Questions and Comments on Tip 2 Stability Reports

**171 Graig Road, Godre'r Graig, Ystalyfera, Swansea
(Formerly Godre'r Graig Infants School)**

Neath Port Talbot Council

JANUARY 10, 2023

Question 4a

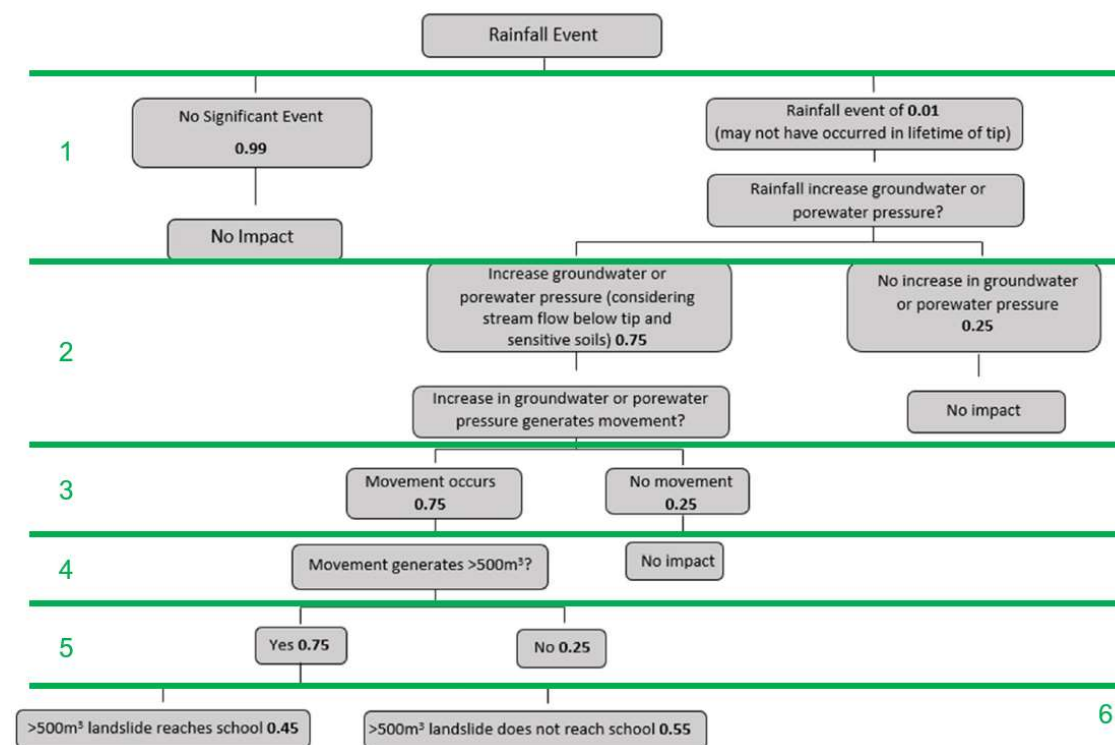
What supporting references / published data / laboratory data / modelling results can ESP/NPTC provide for each level of the decision tree?

Decision Stage	Comment
1	- What is a 1:100 rainfall event? – Is this an annual probability? Or area lifetime probability? - How will the rest of the valley react to a 1:100 event? - Does this tip pose an elevated risk? - Would anyone be using the school in that rainfall magnitude?
2	Stream below tip and “sensitive soils”? What are these? Would the stream have washed the fines away and then pore pressures not likely to increase? How was the case of P=0.75 developed to increase pore pressures? Would land drains help elevate the pore water pressures? Herringbone drainage? Horizontal drains (large diameter)?
3	No reference given for there is a 75% probability that movement occurs. What is the justification for this?
4	What justification for this movement will be over 500 cu m?
5	No justification given for 75%
6	No justification given

An event tree analysis was used in the initial assessment as a graphical construct to show the logical sequence of events or considerations leading to a particular outcome; it is a qualitative approach. The first conclusion was similar to The

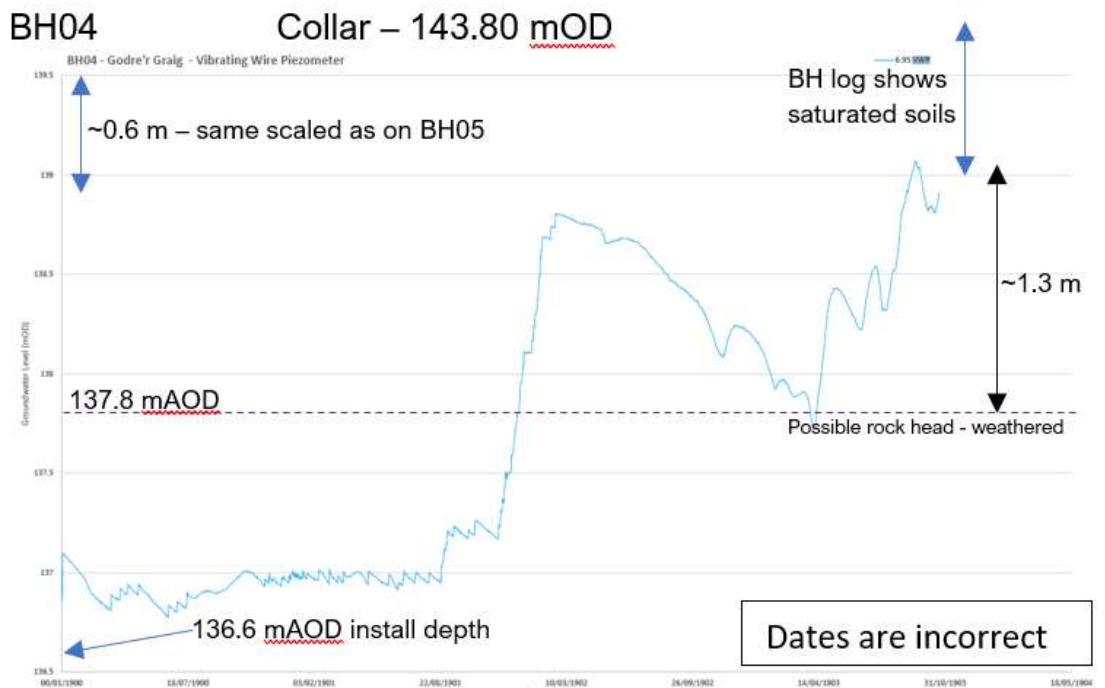
The dates on the data logger for BH04 vibrating wire piezometer plot are incorrect. What inferences can be made on the gradient of the piezometric levels on the plots?

Would all the piezometric data presented (VWP and standpipe dips with notes on rainfall intensity) on one graphical representation of the data give with rain gauge data give a slope level understanding of the water table?

The consideration presented of the vibrating wire piezometer graphs show some incorrect assumptions. We agree that the dates are incorrectly labelled on the vibrating wire piezometer graph for BH04, however, the scale is correct.

BH05 – Collar 157.05

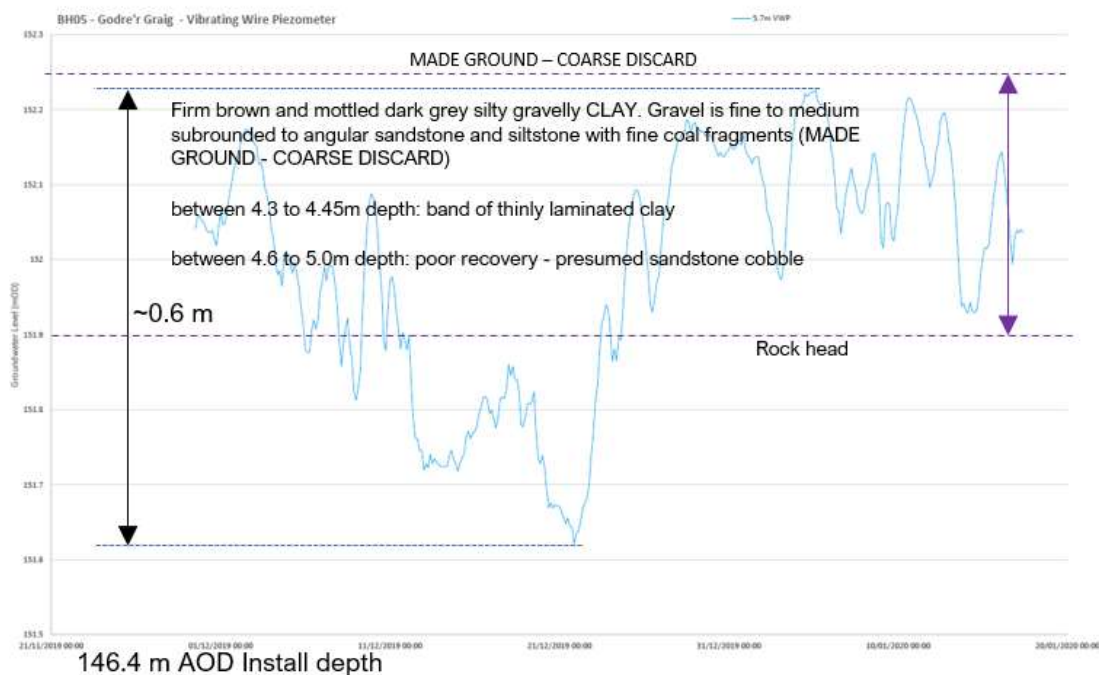
BH05 – appears to show rapid rise and fall of water but the fluctuations appear to be within the clay layer and have not reached the coarse discard. The figure above shows the elevation of rock head and where coarse discard starts. (scale and dates are difficult to read though)

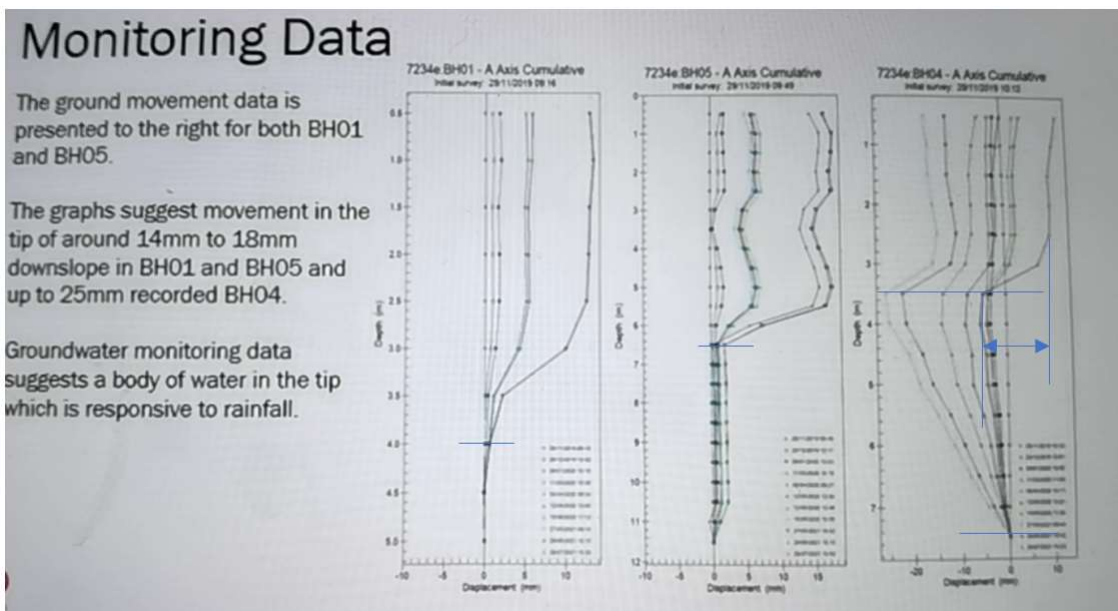
BH01	~4.0 m depth	14 mm total movement
BH05	~6.4 m depth	16 mm total movement
BH04	~7.4 m depth ~3.6 m depth	~23 mm uphill total movement ~13 mm downhill total displacement
BH04 values greyed out due to the spurious readings and potentially not being effectively embedded in a non-moving stratum

To put this into the context of the tip, a drill hole 150mm diameter was driven or hammered through the tip material ranging from clay to 700mm boulders. It is conceivable that a larger particle was pushed uphill slightly and through gravity is settling back. The backfill around the annulus of the inclinometer was noted to be “bentonite/cement surround” It is plausible that the bentonite cement slurry drained away into the tip in one of the more permeable layers.

Does BH04 (and other casings) inclinometer casing show movement as modelled in the Limit Equilibrium Models with the same water table??

Figure 3.9-1 – Colourised slope angles from the Digital Surface Model

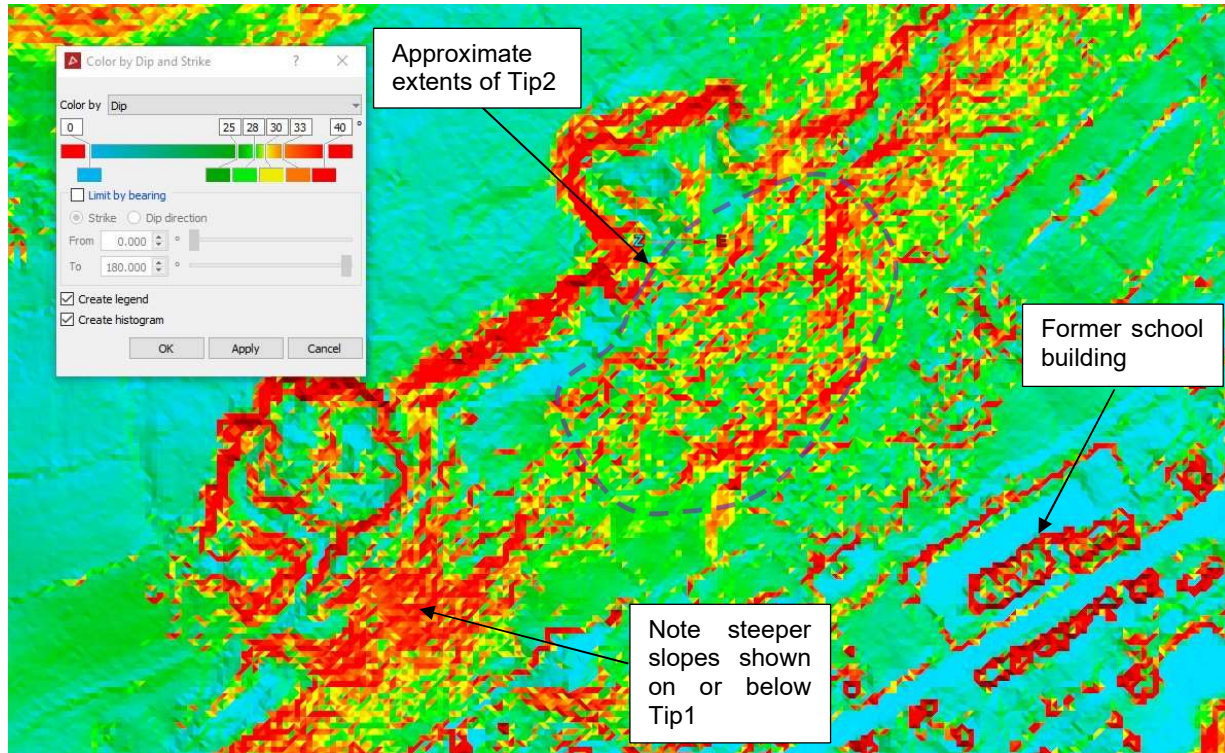
A 27° slope is not as steep as contended by NPTC and ESP who refer to the slope as “*over steep*”. The angle was estimated from ESP’s Limit Equilibrium model (assumed to be natural scale X&Y direction)) and subsequently measured from LiDAR data provided by LLE GeoPortal For Wales.

Figure 3.9-1 was developed from a grid created using lowest return values to provide a topographic ground surface to simulate vegetation removal. The steepness of each cell is represented by a colour. The angles can be seen in the key in the figure. The average dip of the approximate tip extents is 26° dipping towards 137° (southeast).

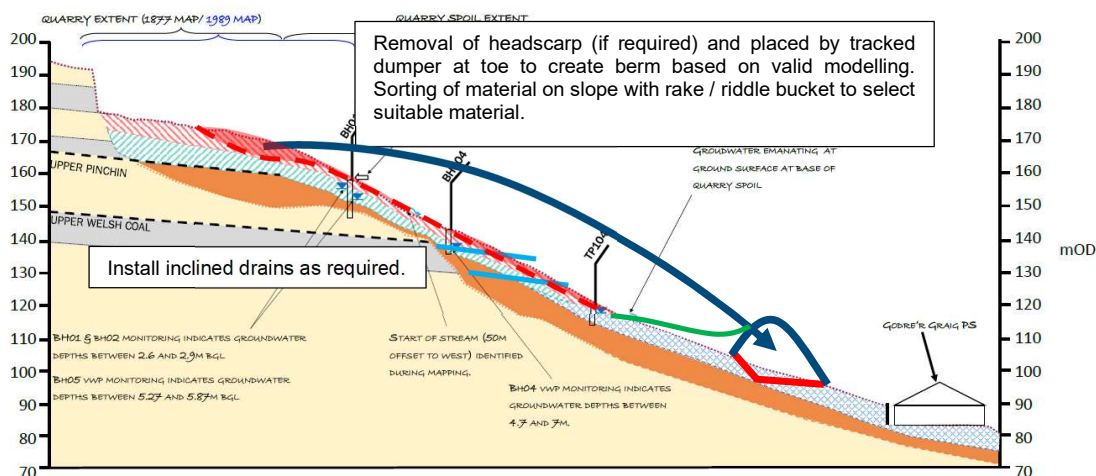
Have ESP/NPTC considered partial removal and partial creation of a deflection berm?

<https://www.menzimuck.com/en/areas-of-operation/special-civil-engineering/> could be used for early enabling work. However, with slope angles in the mid-twenties a bulldozer (D8) could be used to push the material downhill to create the bund and removal of the hazard satisfies the Hazard Hierarchy.

Figure 3.13-2 – Estimate of area occupied by Tip 2

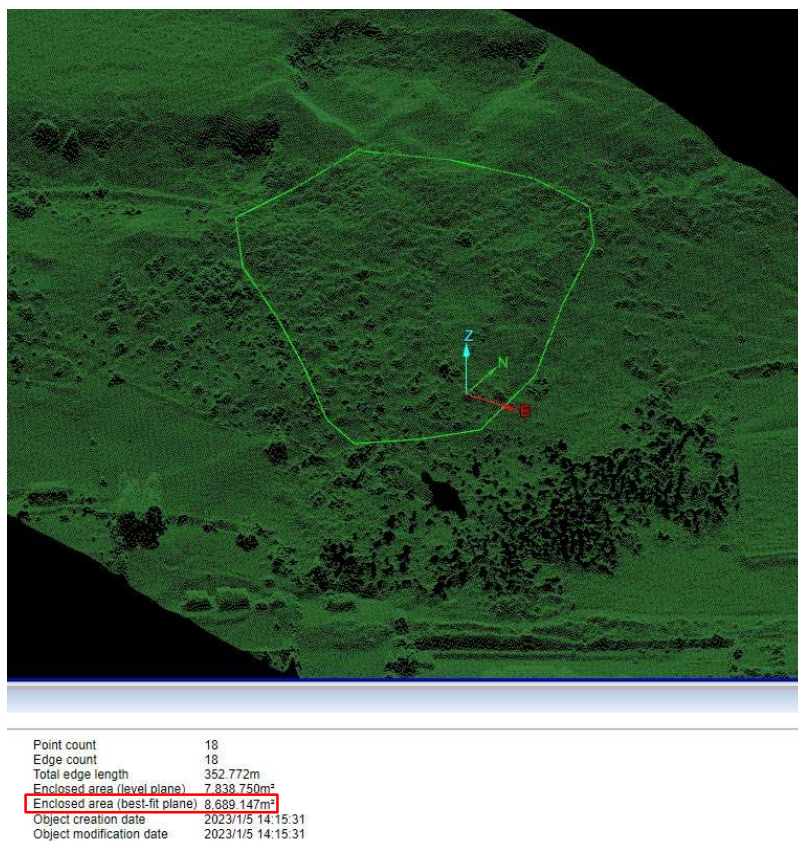
The approximate boundary of Tip 2 was estimated to be 9,000m² (see Figure 3.13-2). Using NPTC's consultant's estimate of Tip 2's volume of 87,395m³. $87,395\text{m}^3 \div 9,000\text{m}^2 = 9.71\text{m}$ thickness of end tipped coarse discard across the slope. The topography of the slope suggests that this is incorrect as the tipped material tapers into the hillside (See Figure 3.13-3 below). Especially as the thickest deposit as modelled is in the old quarry workings.

ESP Figure 2 – Geomorphological Mapping

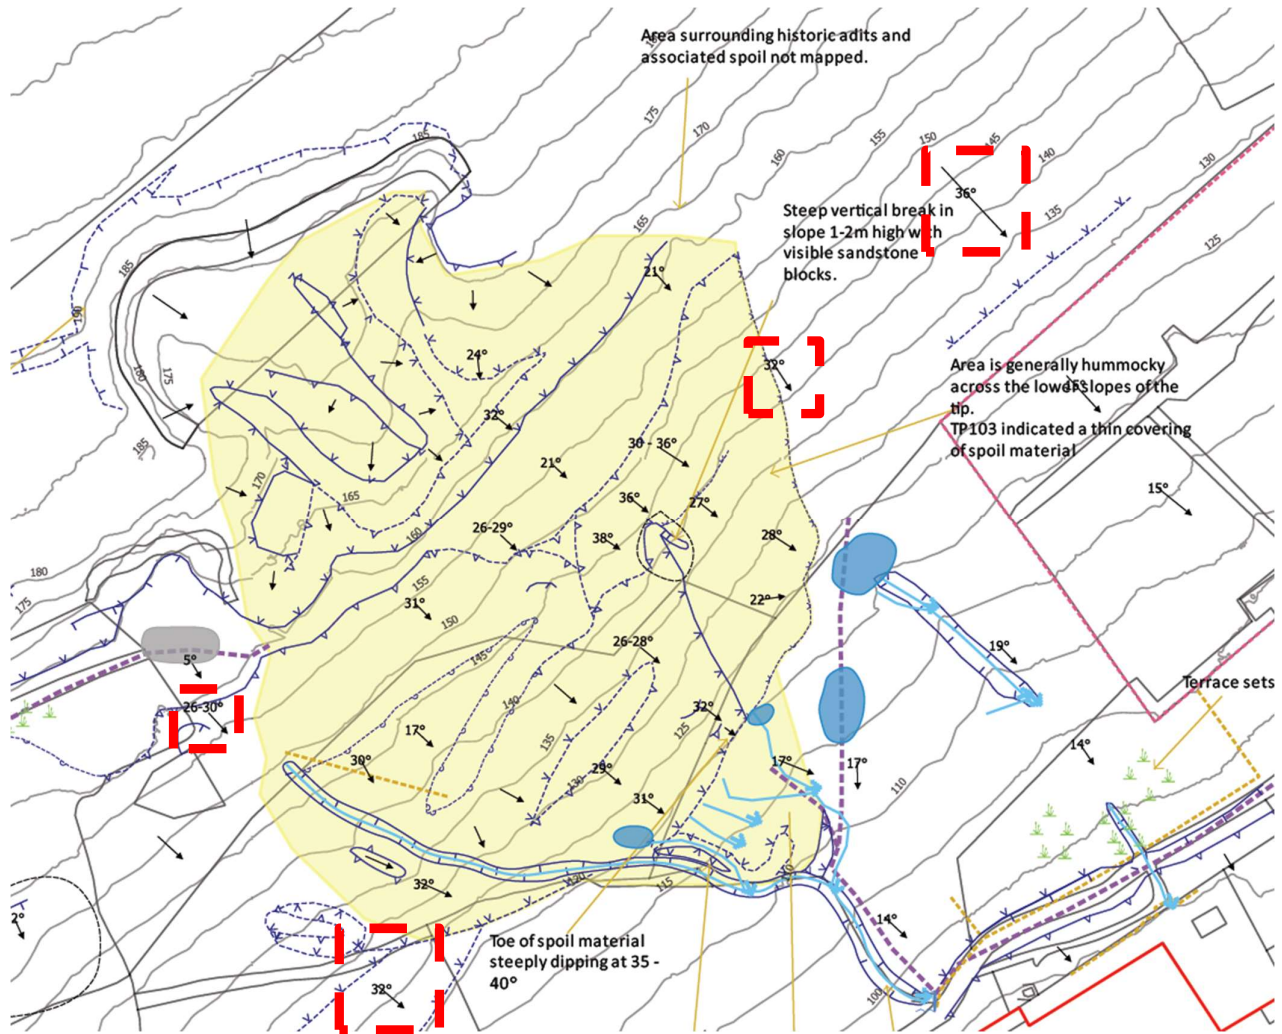
Slope angles measured on the tip (visually and via topographic survey) are provided in the report. Many slopes are steeper than 27° (Tegwch suggested maximum) with slopes as steep as 38°, see Figure 2 in ESP.7234.02.3302.

NPTC suggest that ESP.7234.02.3302 Figure 2 shows relatively short sections of slope steeper than 30° and some measurements taken on natural hillside (outside the mapped extents of Tip 2) to be 36° - presumably the angles on the natural hillside are not over steep and have an acceptable Factor of Safety. NPTC should confirm?
